**RAI: Volume 3, Chapter 2.2.1.3.3, First Set, Number 1:**

Provide the following additional technical bases to demonstrate that measured pore-water compositions can be used in SAR Section 2.3.5.3 to adequately represent the range of compositions in the natural system and can be used to determine the initial water compositions for the near-field chemistry model:

Figure 1. Range of Chloride Concentrations in Screened-in and Screened-out Water Samples

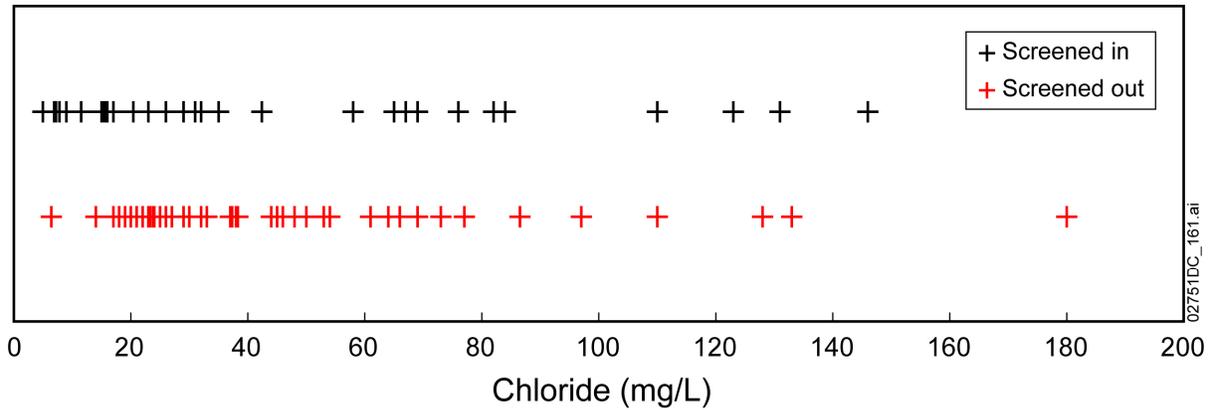
- (b) Support for the range of initial water compositions for conservative anions, such as chloride ( $\text{Cl}^-$ ) and nitrate ( $\text{NO}_3^-$ ) that are important to corrosion.

With respect to chloride concentrations, support for the representativeness of the 34 selected water compositions is provided by comparison to the other 56 pore waters that were screened out as being affected by microbial activity during core storage. The screened-out waters can be used for this because microbial activity does not affect chloride concentrations. Although these sample populations are not entirely independent (some waters in each group were collected at the same locations), similarity in the two groups would indicate that they are both representative of the same overall population, and provide support that the population is adequately represented. The 56 waters represent more sampling sites than the 34 waters that were screened in, because they include sample sites along more than 2 km of the Enhanced Characterization of the Repository Block Cross-Drift. The chloride concentration range of the screened-in waters bounds that of the screened-out waters, except for two samples, both with chloride concentrations of 180 mg/L (Figure 1). Cumulative distribution functions for the two data sets are provided in Figure 2. The distributions have nearly identical means and standard deviations. When evaluated using the Wilcoxon Rank Sum Test, a p-value of 0.468 (47%) is calculated. This value represents the probability of incorrectly rejecting the hypothesis that the two sample groups represent the same population; the large value (5% is commonly used as a cutoff) does not indicate that the two samples represent the same population, but rather that they are

similar enough that it is not possible to conclude that they do not. Therefore, the screened-out pore-water samples provide additional confidence that the 34 screened-in samples are representative of the range of chloride concentrations at the site.

Figure 4. Evaporative Evolution of the 34 TSw Pore Waters Used in the NFC Model ( $p\text{CO}_2 = 10^{-3}$  bars;  $T = 25^\circ\text{C}$ )

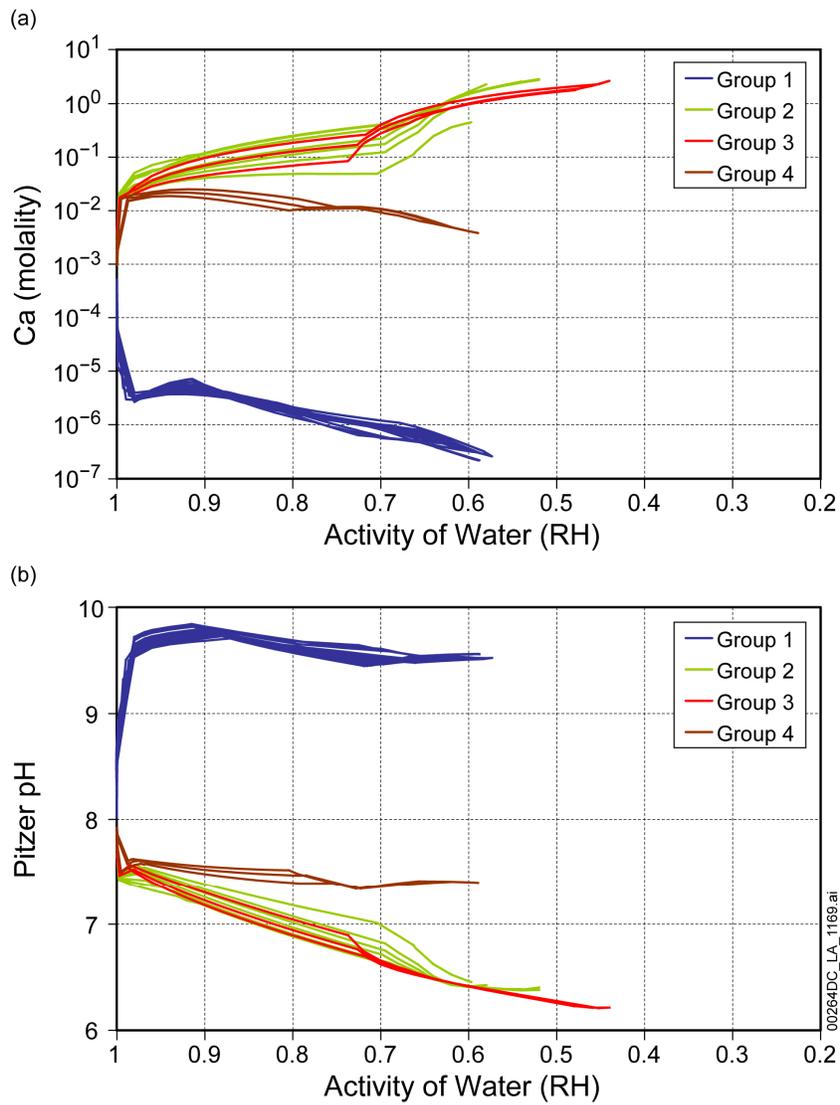
- (d) An explanation of uncertainty and its propagation in the near-field chemistry model and performance assessment model. Also address the likely process-level causes for the bimodal distribution of the 34 sample compositions that passed the quality screening criteria (SAR Figure 2.3.5-9).

To explain how these waters are used and how uncertainty in initial water compositions is propagated through to the TSPA-LA model, it is necessary to explain how the NFC model couples with the seepage evaporation abstraction and with the TSPA-LA model (SAR Sections 2.3.5.3.4 and 2.3.5.5.4). This is illustrated in a flow chart in Figure 5. The four waters identified in Table 1 are used as the starting waters in the NFC model. Because TSPA calculations do not use seepage water compositions (representing seepage before it enters the drift) directly, but rather calculate in-drift water compositions, these four starting waters are not used to calculate a time history of seepage compositions. Instead, the four waters are used to parametrically generate a set of seepage water compositions, in the form of EQ3/6 pickup files, at 11 discrete water–rock interaction parameter (WRIP) values (amounts of feldspar dissolved), and at three different temperatures (30°C, 70°C, and 96°C) for use as initial water compositions by the in-drift seepage evaporation abstraction. There are a total of 132 pickup files ( $11 \times 4 \times 3 = 132$ ). The seepage evaporation abstraction in turn generates 396 lookup tables by simulating evaporation of the 132 seepage water compositions at *p*CO<sub>2</sub> values of 10<sup>-2</sup>, 10<sup>-3</sup>, and 10<sup>-4</sup> bars; the temperatures used are the same as those used in the NFC model calculations, except 100°C is used instead of 96°C. The seepage evaporation abstraction lookup tables provide potential in-drift water compositions as a function of relative humidity. Each lookup table is identified by four parameters—the initial group water (4), the WRIP value (11), the temperature (3), and the in-drift *p*CO<sub>2</sub> (3).

Figure 1. Flow Chart Illustrating How the Near-Field Chemistry Model and Seepage Evaporation Abstraction Are Integrated into the TSPA

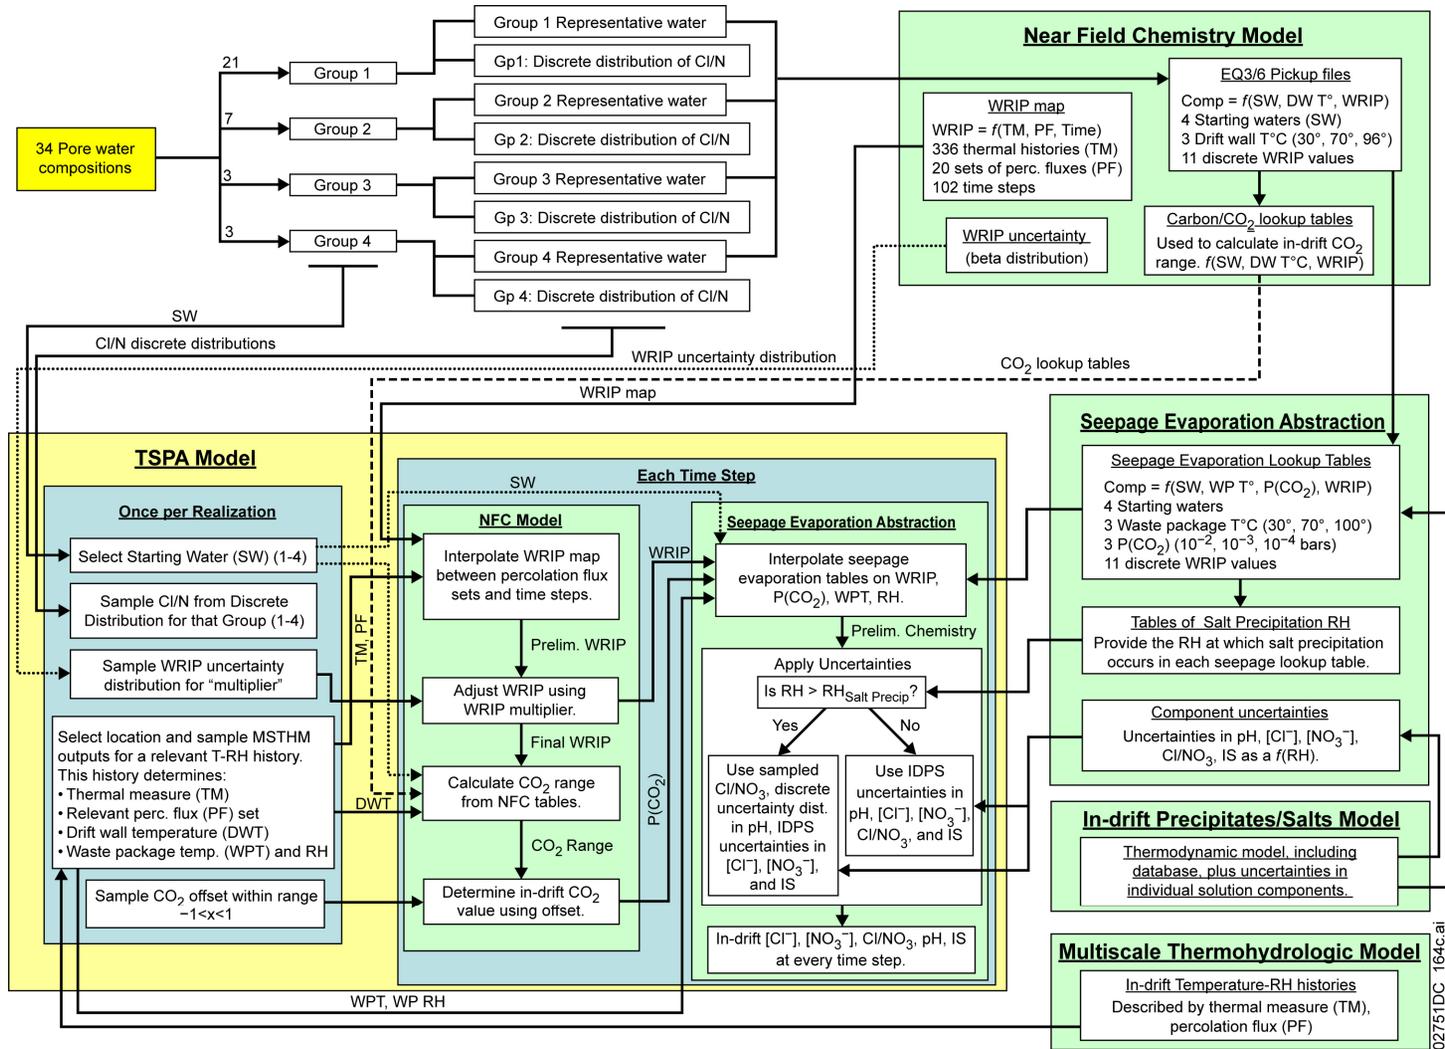
Provide the following additional technical bases to demonstrate that the near-field chemistry (NFC) model adequately calculates a range of water compositions in the natural system:

The integration of the NFC model with the seepage evaporation abstraction and within TSPA is illustrated in Figure 1. Inputs to the NFC model (other than parameter values) consist of the four representative group waters. The NFC model does not produce a time history of seepage water chemistry. Instead, it produces four outputs, all of which are parametric, and which are combined only within the TSPA model when evaluating in-drift chemistry. The four outputs are:

Figure 10. Plot Showing the Relationship between Calculated Ambient Feldspar Dissolution Rates and Activation Energy for Different Possible Thermal Histories (A through E)

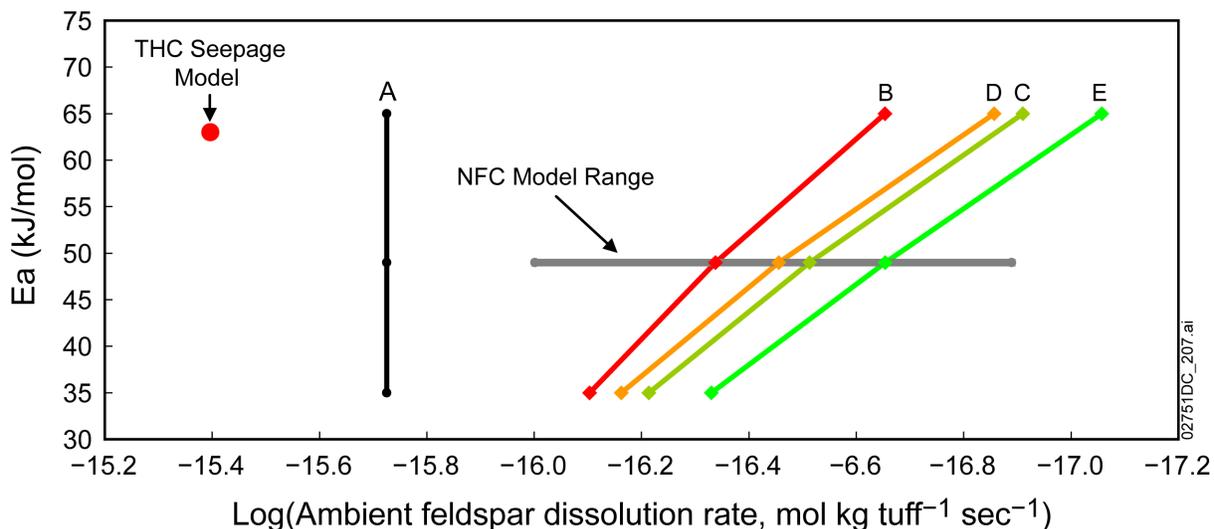
The basis of the RAI suggests that the ambient feldspar dissolution rate and  $E_a$  used by the THC seepage model might constitute an alternative conceptual model. The following discussion describes why the treatment of these parameters in the NFC model is more appropriate for application in the TSPA.

For each of the possible thermal histories, the cumulative amount of feldspar dissolved is integrated through time, using the  $E_a$  to adjust the dissolution rate from the ambient value for each time interval. The combinations of ambient dissolution rate and  $E_a$  values that reproduce the average observed cumulative feldspar dissolution are calculated for histories A through E. The results of these calculations are summarized in Figure 10. The lines A to E represent the possible thermal histories discussed above; in each case, ambient feldspar dissolution rates were calculated for  $E_a$  values of 35, 49, and 65 kJ/mol. Line A represents the rate derived by simply taking the total observed alteration and dividing by 12.8 million years. The range used in the NFC model, and the point corresponding to the rate and  $E_a$  values used in the THC seepage model, are also plotted. The NFC model range for the ambient feldspar dissolution rate bounds the range of values calculated with the different possible thermal histories for the TSw tuff. For the THC seepage model values to conform with this analysis, either the feldspar dissolution rate or  $E_a$  must be much smaller.

There are two assumptions in these calculations. First, it is assumed that the same ambient alteration rate applies throughout time. This is not likely to be correct; in general, silicate dissolution rates are observed to decrease greatly with age in natural systems. However, the net effect of having a faster rate in the past is that the present-day dissolution rate would have to be even slower. Second, it is assumed that the feldspar dissolution rates at any given time are mostly a function of temperature and not of water composition; that is, there is no feedback to reduce the rate of feldspar alteration relative to that predicted using the Arrhenius relationship.

Figure 1. Piper Plot for Compositions of Perched Water and Pore-Water Samples from Table 1

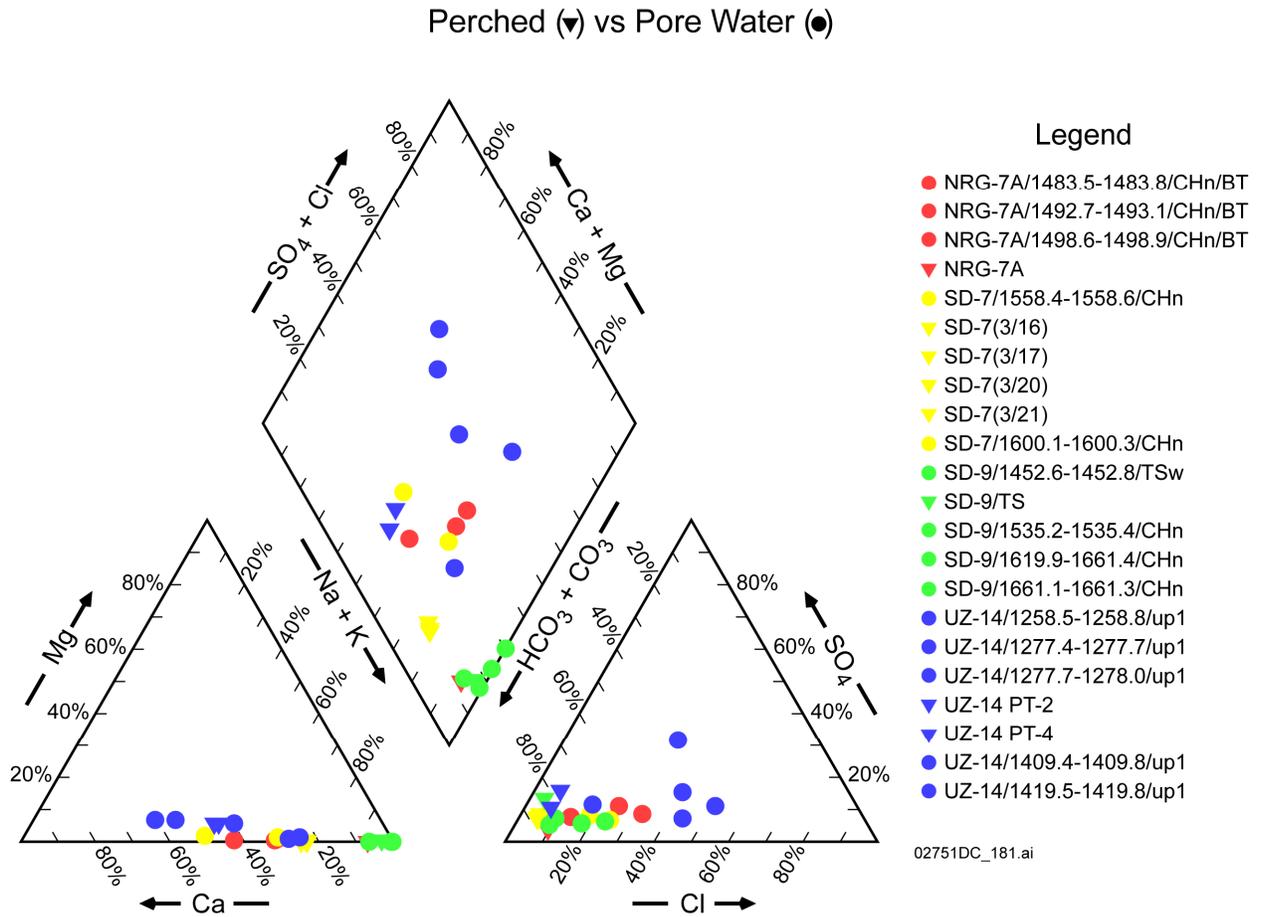
The NFC model assumes chemical equilibrium between fracture and matrix waters. Fast flow-path fracture flow may cause chemical disequilibrium between fracture and matrix waters; thus the NFC model may not adequately represent the potential range of seepage water composition. Provide additional technical bases supporting the assumption that fracture and matrix waters are in chemical equilibrium. Demonstrate that seepage water compositions calculated using the NFC model adequately represent the potential range of seepage water chemistry.

Pore waters from core samples originating above and below perched water bodies have chemical characteristics (particularly the range of chloride concentrations) that are more similar to one another than to perched waters (Figure 1). The chloride content of perched waters is so low that it overlaps that of precipitation. Given the presence of old chloride-containing soils, such low

chloride concentrations cannot be preserved by net infiltration that occurs over most of the Yucca Mountain site. This indicates that the perched waters were recharged during colder climates, along isolated, fast pathways. An alternative explanation is that perched waters, being similar to saturated zone water, may have originated from higher water tables and/or lateral flow from the north where the groundwater table is at a higher elevation. For either explanation of origin, pore water and perched water have distinctly different geochemical evolution and have undergone different degrees of evaporation, water-rock interaction, or both (SAR Section 2.3.2.3.4.1). Thus comparisons between perched and pore-water compositions cannot be used to evaluate model predictions of fracture-matrix interaction in the unsaturated host rock.
